APPEAL SUMMARY

Appeal ID: 23380	Project Address: 8230 SE Yamhill St
Hearing Date: 1/29/20	Appellant Name: Ginger Hebert
Case No.: B-001	Appellant Phone: 503-267-3189
Appeal Type: Building	Plans Examiner/Inspector: Peter Drake
Project Type: commercial	Stories: 3 Occupancy: B Construction Type: V-N
Building/Business Name:	Fire Sprinklers: No
Appeal Involves: Alteration of an existing structure LUR or Permit Application No.: 18-273800-CO	
Plan Submitted Option: pdf [File 1] [File 2]	Proposed use: Office -

BUILDING CODE APPEAL - REVISION REQUEST
BUILDING PERMIT #18-273800

WELLNESS CLINIC / HEBERT REMODEL

BLD.01
REVISION REQUEST

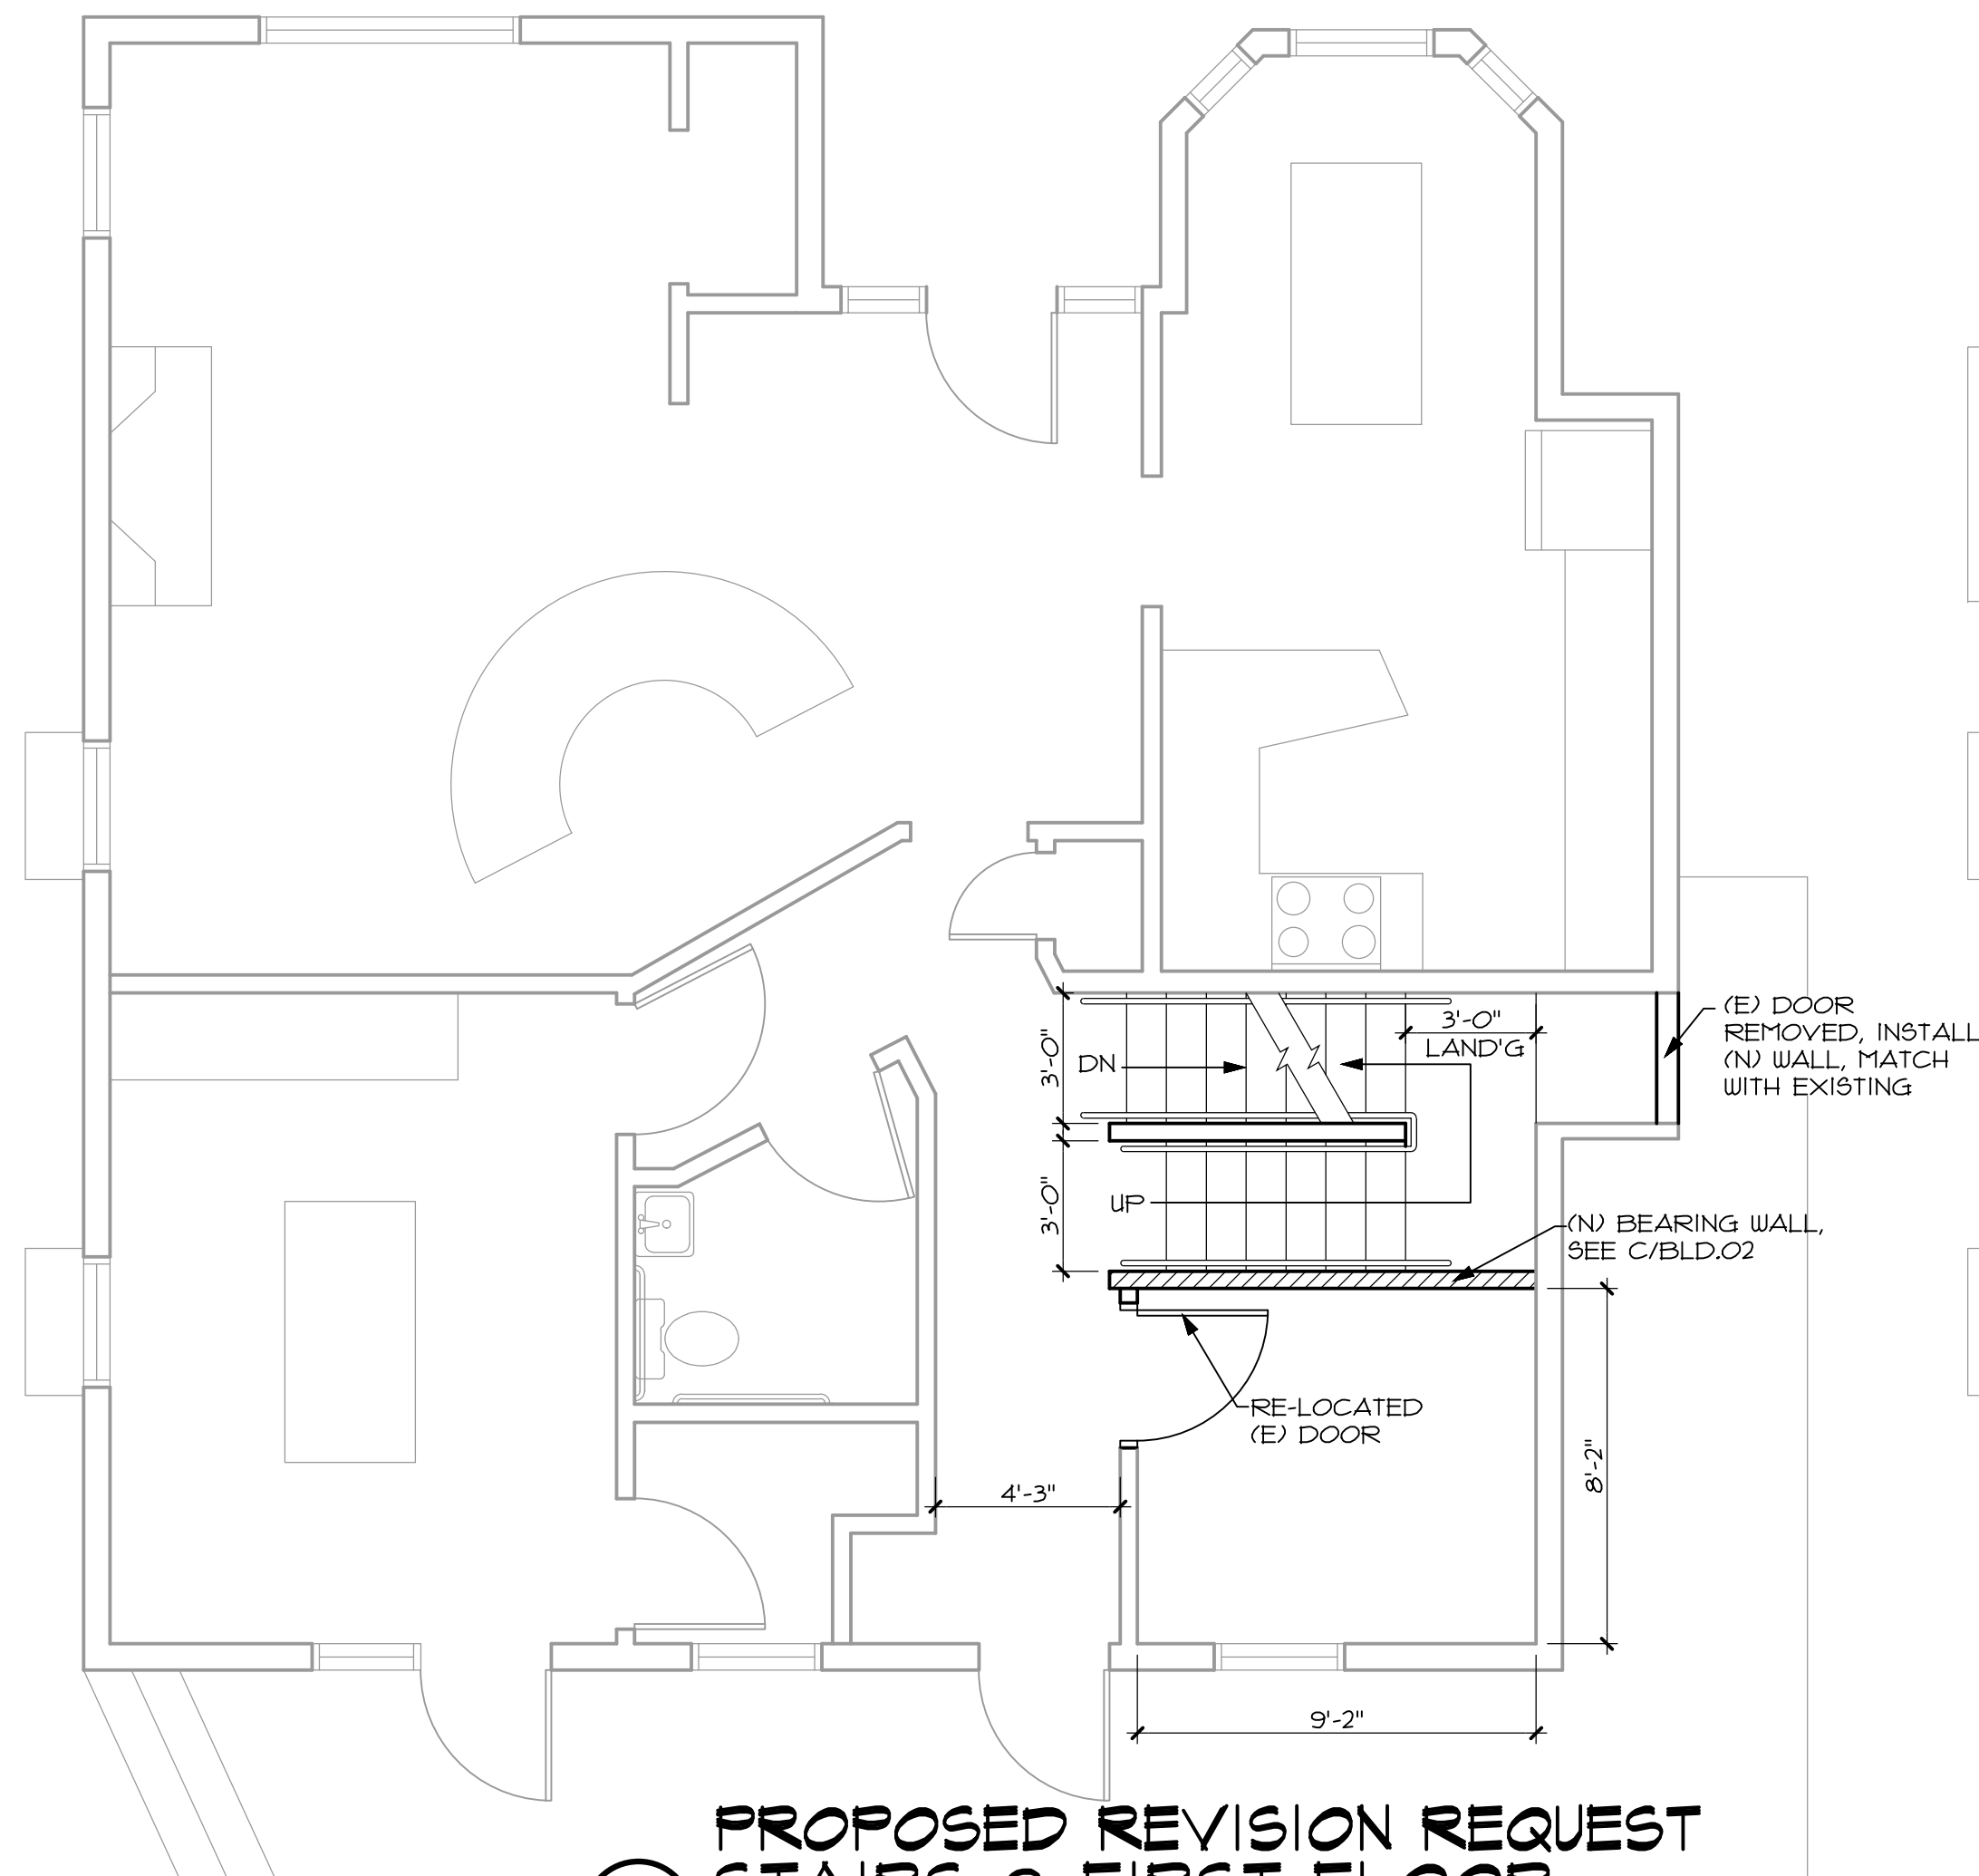
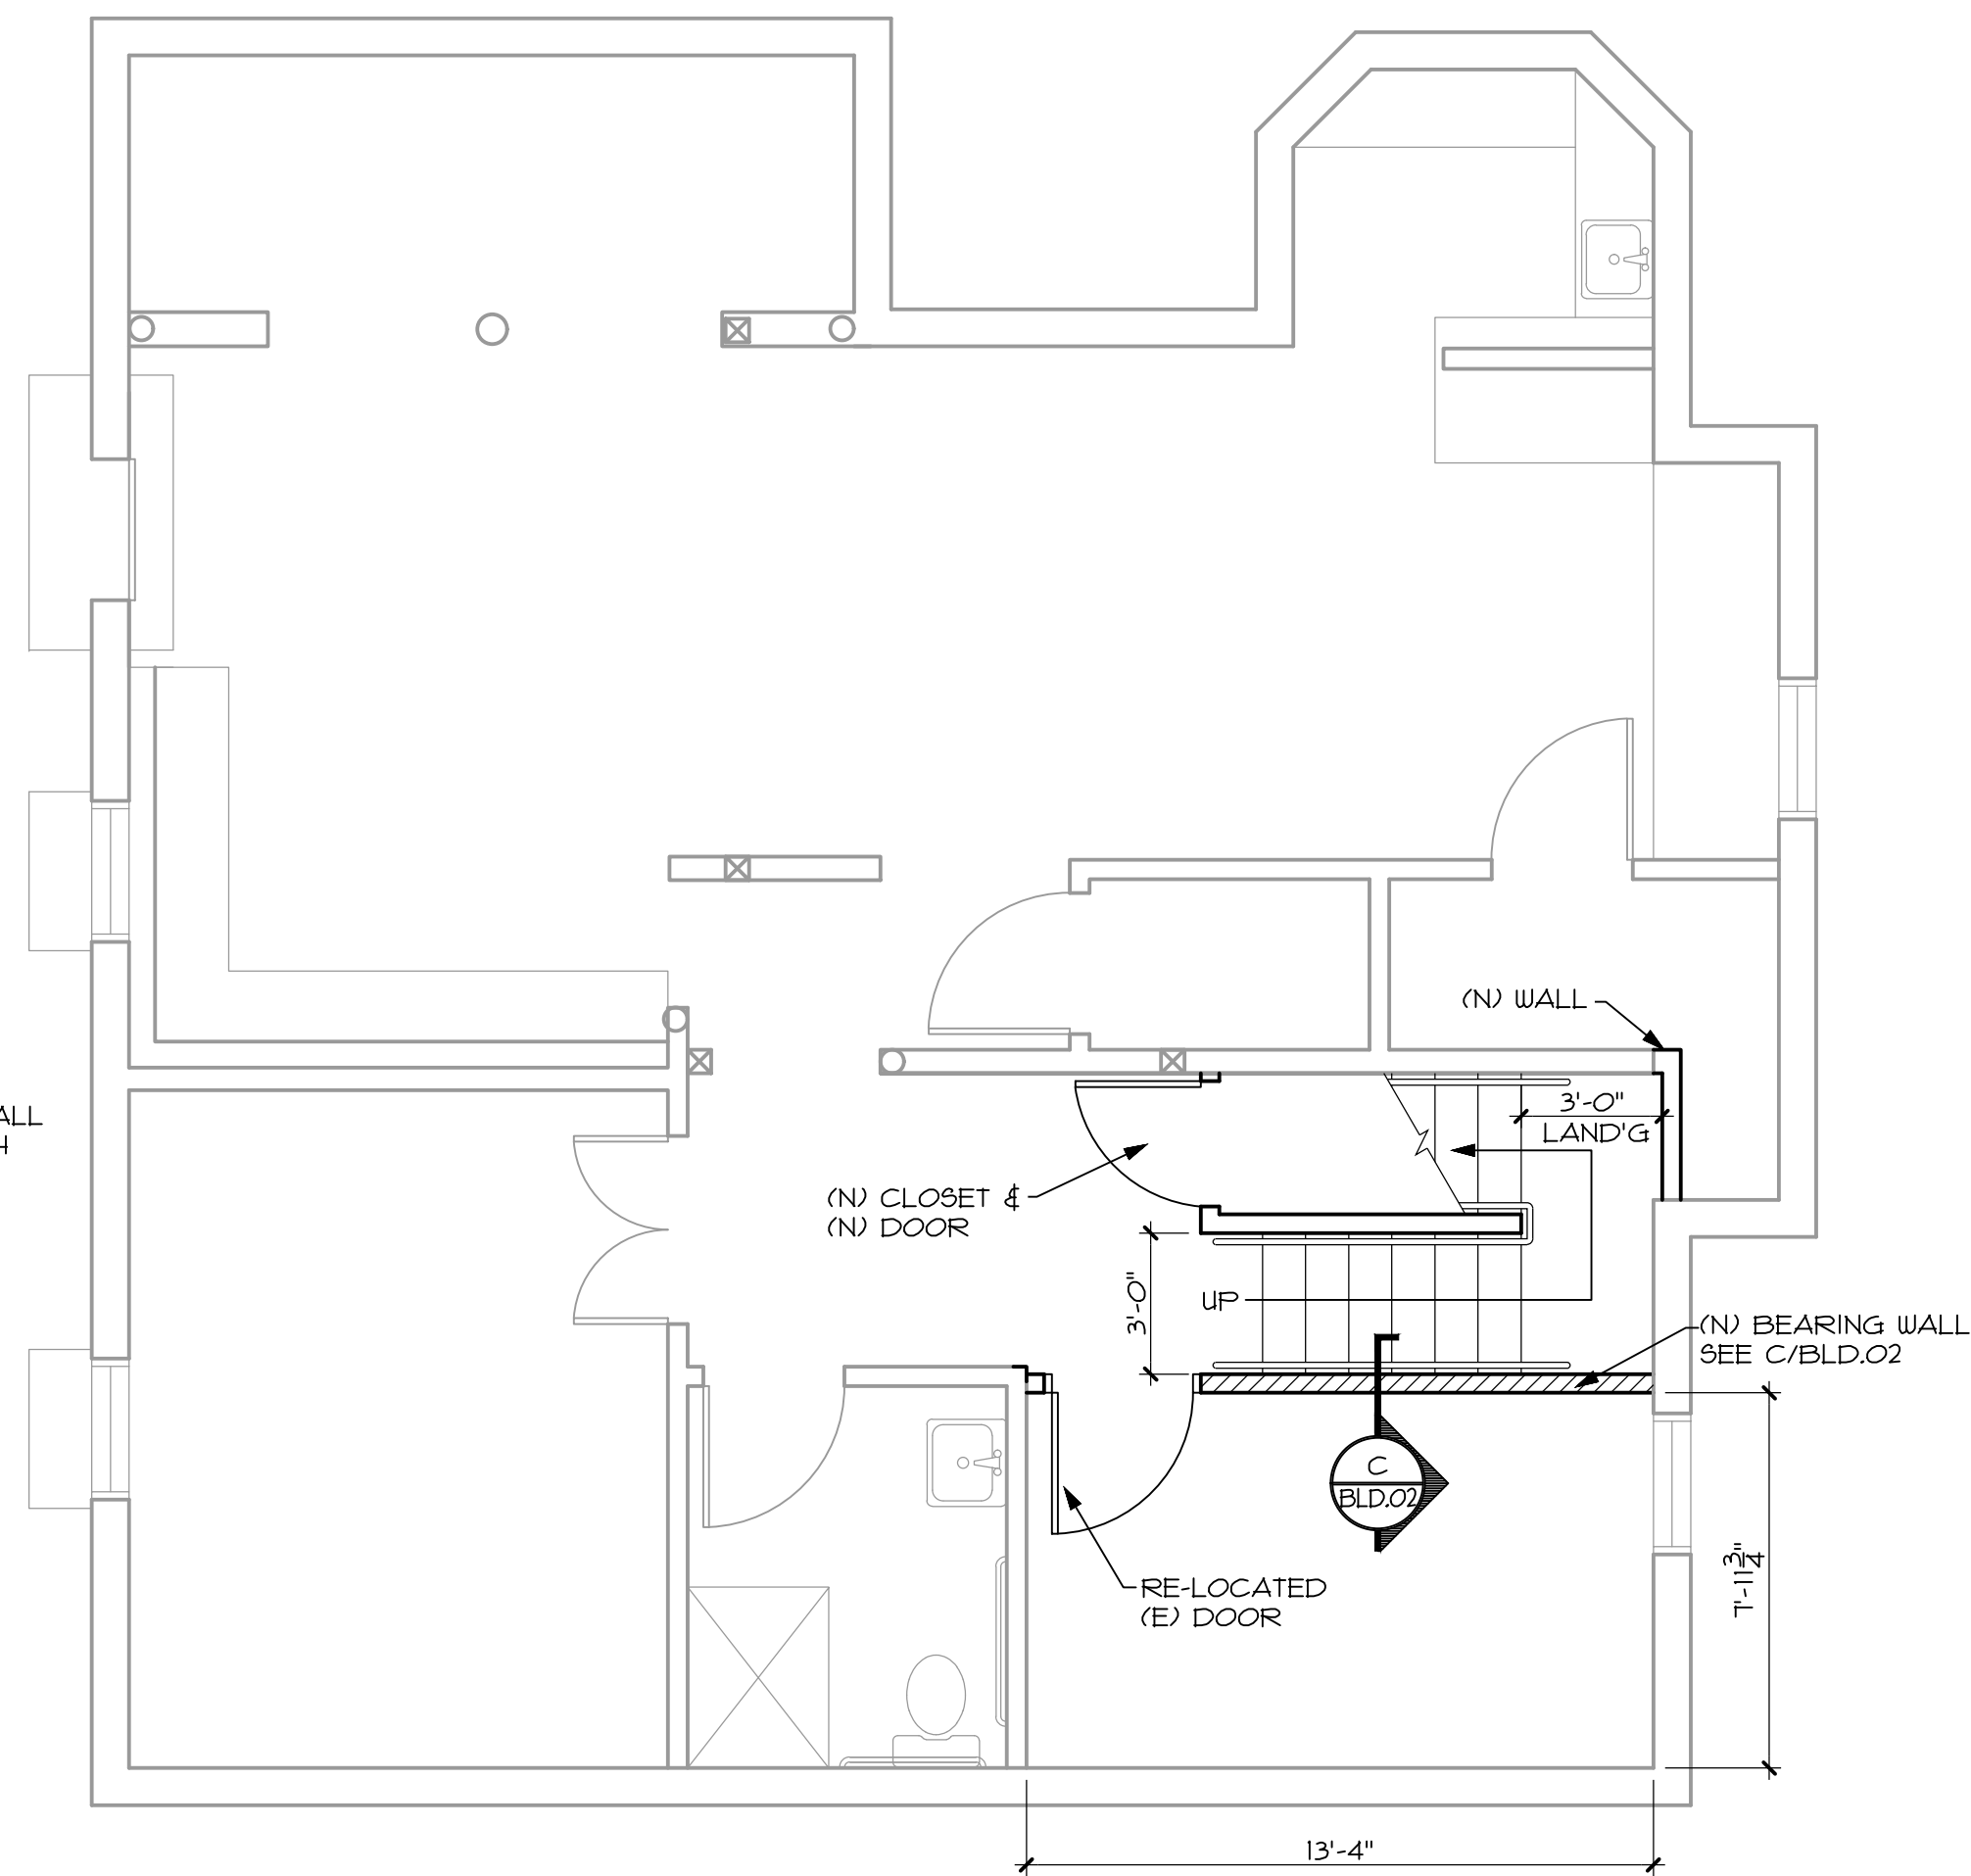
Code Section	2019 Oregon Structural Specialty Code, Chapter 10
Requires	Chapter 10 - Mean of Egress Section 1019- Exit Access Stairways 1019.3..exit access stairways...shall be enclosed with a shaft enclosure..
Code Modification or Alternate Requested	The proposed non-compliant revised stair configuration will substantially improve life safety and overall exiting conditions over the original, initially approved, now demolished, residential "winder" stair design as part of the Change of Occupancy approvals.
Proposed Design	The Appellant proposes anew 36" wide wood frame stair with 180deg. half landing turn. The stair rise and run, handrail locations, and head clearances all meet 2019 OSSC requirements; with the exception of the Code Appeal Section 1019.3. regarding the enclosed shaft requirement. (See Sheet BLD.03) The revision proposes the elimination of the side door (which would require 1-hr rating) for the basement exit, but rather connects the basement directly to the main floor improves the path of travel from the basement to public way. The revision also eliminates the "winder" stair to the second floor, the main floor provides two exits as previous described. (See Sheet BLD.02) This new stair will not only improve life safety but also the functional flow, circulation, security and safety of the clinic.

Reason for alternative	Previous contractor removed the original residential stair(s). These stairs had been permitted as a non conforming, existing condition, but have been removed and no longer exist. If reconstructed as originally designed, the stairs would be too steep, too narrow, with inadequate landings, and insufficient clearances. This original stair configuration consisted of a single flight from basement to an exterior side door, and stacked above, a "winder" stair from main floor to 2nd. The stairs are not contiguous, but are stacked, reliant and dependent on combined layout for vertical clearances

and landings. The basement stair leads upstairs to a narrow 30" landing, (located approx. 24" below main floor), to then exit through a side door directly into a 36" sideyard. The second-floor stair discharges to the main floor with two exits; one to the front street yard and the second to the rear yard. (See Sheet BLD.01)

Reconstruction of existing stairs to connect 3 stories with omission of rated shaft enclosure: Denied.
Proposal does not provide equivalent Life Safety protection.
Appellant may contact John Butler (503 823-7339) with questions.
